Project	IEEE 802.16 Broadband Wireless Access Working Group < http://ieee802.org/16 >	
Title	Fix for HO Race Condition Issue	
Date Submitted	2005-07-14	
Source(s)	David Xiang, Phillip Barber, Jim Carlo, Duke Dang, Lucy Chen, John Lee	mailto: dxiang@futurewei.com
	HUAWEI	
Re:	Call for contribution and comments.	
Abstract	Fix for HO Race Condition Issue.	
Purpose	Adoption	
Notice	This document has been prepared to assist IEEE 802.16. It is offered as a basis for discussion and is not binding on the contributing individual(s) or organization(s). The material in this document is subject to change in form and content after further study. The contributor(s) reserve(s) the right to add, amend or withdraw material contained herein.	
Release	The contributor grants a free, irrevocable license to the IEEE to incorporate material contained in this contribution, and any modifications thereof, in the creation of an IEEE Standards publication; to copyright in the IEEE's name any IEEE Standards publication even though it may include portions of this contribution; and at the IEEE's sole discretion to permit others to reproduce in whole or in part the resulting IEEE Standards publication. The contri

Problem Definition

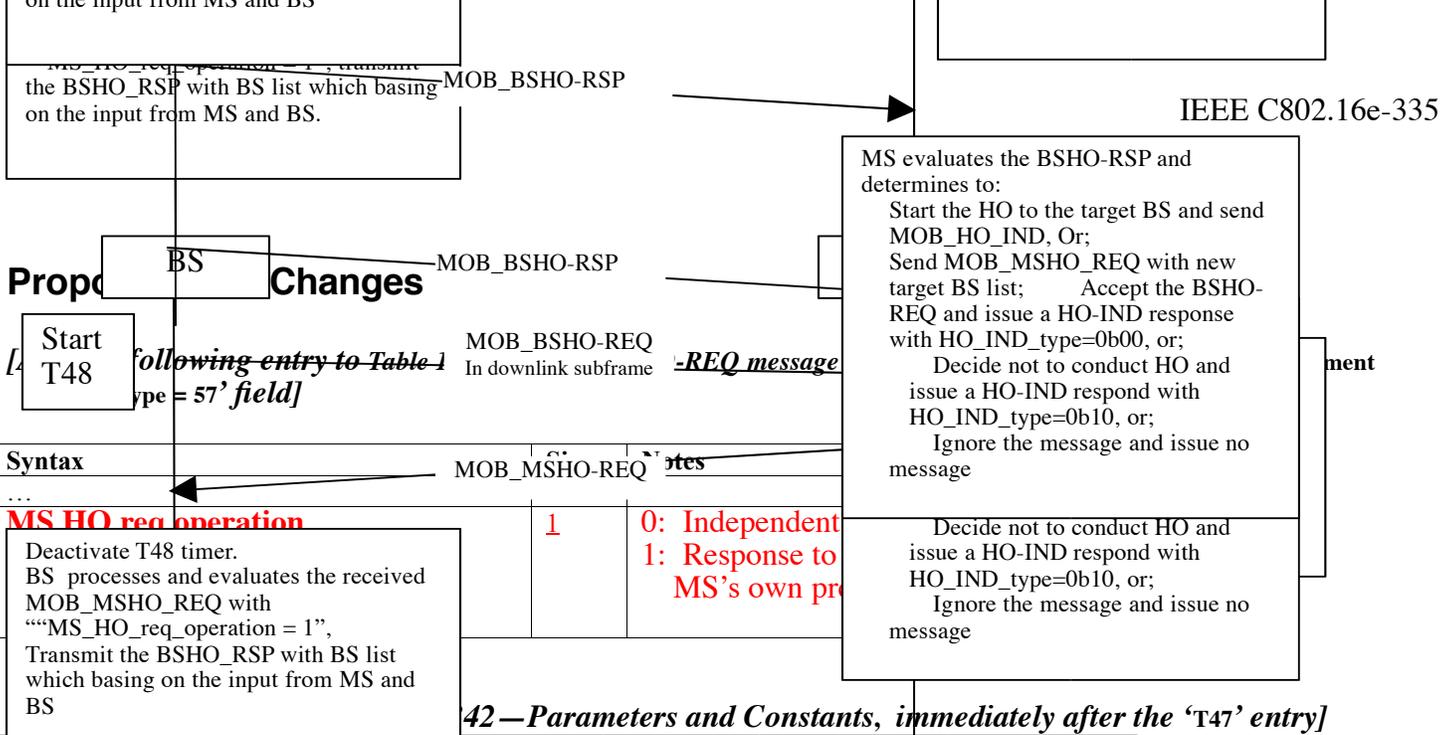
Handover can be initiated either by BS or MS independently based on information they collect. Therefore, it is highly possible that the MS and BS may initiate the HO by sending HO request to each other at the same time (in the same frame) without knowledge that the peer is also initiating HO request, creating a race condition. The current standard has the following definition to handle this race condition.

“If an MS that transmitted a MOB_MSHO-REQ message detects an incoming MOB_BSHO-REQ message, it may respond with a MOB_MSHO-REQ or a MOB_HO-IND message and ignore its own previous request. A BS that transmitted a MOB_BSHO-REQ message and detects an incoming MOB_MSHO-REQ message from the same MS shall ignore its **MOB_BSHO-REQ [emphasis added]**. A BS that transmitted a MOB_BSHO-REQ message and detects an incoming MOB_HO-IND message from the same MS shall ignore its own previous request.”

NOTE: the bold text is the corrected message. This was changed in error, breaking message flow, for the D8 document and carried into the D9 document and there is a comment to remedy this.

Under the situation which BS transmits MOB_BSHO_REQ and MS transmits MOB_MSHO_REQ at the same time (or at least within the message processing latency), the problems of the current standard definition are:
